# Proposal on AMS ID and location Privacy

IEEE C80216m-09/0181r1

Topic: Security, AMS privacy, sub section 10.6.2.1

**Figure 1. AMS Privacy during NW entry**

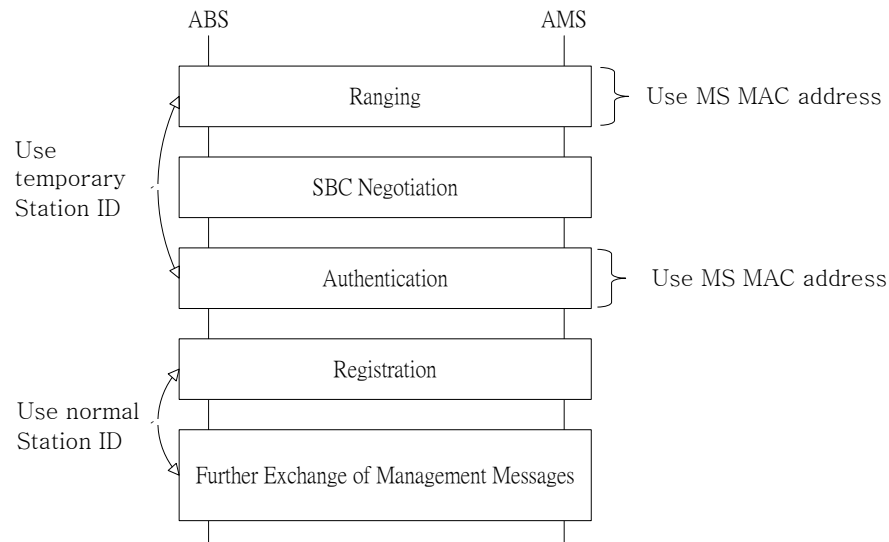
There is no remedy for AMS privacy in SDD yet. If relationship between MS MAC address and normal station ID is hidden, AMS privacy can be achieved even though the MS MAC address is transmitted as a plaintext. We suggest using Temporary station ID, which the ABS assigns the AMS, to hide the relationship.

This is the steps for hiding the relationship between MS MAC address and normal station ID during initial Network entry. (see Figure xxx)

1. The AMS sends AMS ID(e.g. MS MAC address) for MS identification to ABS.
2. ABS allocates a temporary station ID, which is used until the AMS obtains a normal station ID.
3. During the authorization/authentication procedure, ABS and AMS become to share security keys which is used to encrypt management message. (During the authorization/authentication procedure AMS may transmit the MS MAC address to ABS for device authentication.)
4. ABS assigns securely normal station ID to AMS, which is sent through the encrypted management message.
5. The assigned normal station ID is used from a negotiated time.

Figure xxx.yyy AMS Privacy during NW entry

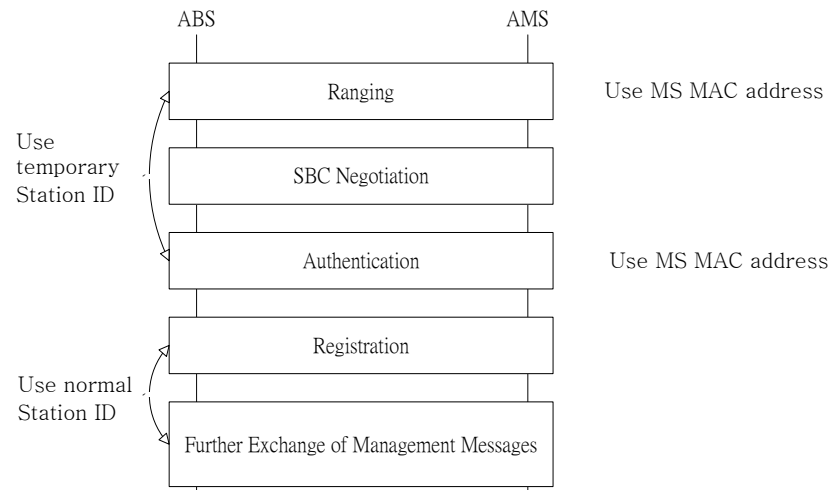
~~In reference system there is no explicit means by which identity of user is protected. During initial ranging and certificate exchange during authorization MS MAC Address (MS ID) is transmitted in the clear. Hence, the identity or location information can be easily inferred from fixed MS MAC address, result of which violates the security aspects of IEEE 802.16m SRD. Detailed method for providing AMS ID privacy is FFS.~~

AMS privacy is provided by hiding relationship between MS MAC address and normal station ID.

During initial network entry, the AMS and ABS use MS MAC address for MS identification . When the AMS sends MS MAC address to ABS for MS identification, the ABS allocates a temporary station ID, which is used until the AMS obtains a normal station ID. During the authorization/authentication procedure, ABS and AMS share security keys which is used to encrypt management message. ABS assigns station ID to AMS, which is sent through the encrypted management message, and the station ID is used from a negotiated time. Figure xxx.yyy illustrates an example of identity privacy and location privacy.
